# VALIDATION REPORT

**Kolar Biogas Project**

**SGS Climate Change Programme**

| 28-06-2011  |              | CDM.VAL2153   |  |                         |

Figure [1]

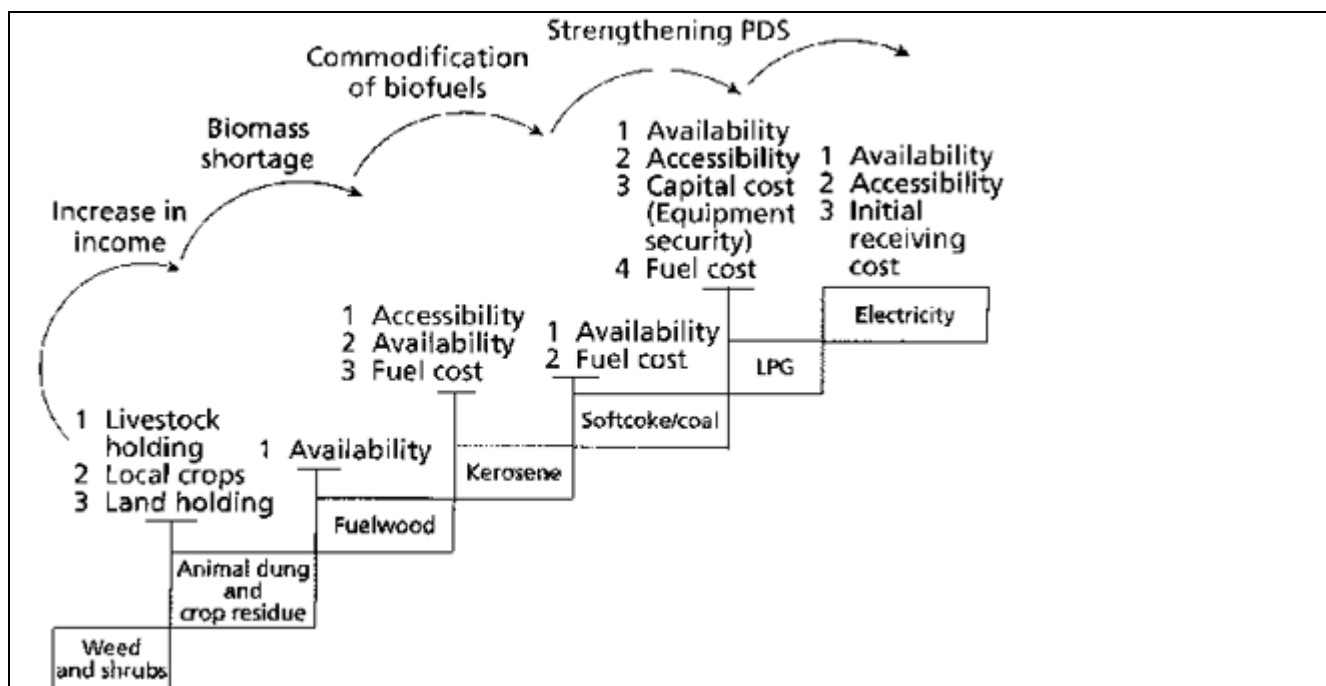
| Type: | CAR        | Number: | 08         | Reference:          | Section B.4.4 |

The lower use of Kerosene for cooking in comparison with fuel wood is supported by external references e.g. the Preeti Malhotra article ‘Environmental implications of the energy ladder in rural India’ (<http://www.hedon.info/EnvironmentalImplicationsOfTheEnergyLadderInRuralIndia>) (reference 7, Annex 5 of PDD V03) which gives a scheme of the energy ladder in rural India shown in figure 1 which demonstrates that kerosene is the next fuel used after fuelwood or fuelwood mix with crop residues. I.e., households need more income to overcome the barrier presented by fuel costs.

Figure 1 gives the Energy Ladder in Rural India, and barriers inhibiting transition to commercial fuels for cooking. Factors that can bring about transition to commercial fuels are highlighted in the boxes Section B.5, pages 25 -27 ((a) Use of kerosene for all cooking purposes) of the PDD V03 has been modified to reflect the above clarification.

(<http://www.hedon.info/EnvironmentalImplicationsOfTheEnergyLadderInRuralIndia>), shown in figure 1 above, which demonstrates that LPG systems are the third fuel used after fuelwood or fuelwood mix with crop residues. The high cost of LPG systems is also supported by an article on kerosene and gas stoves in South India published on HEDON (Household Energy Network) website
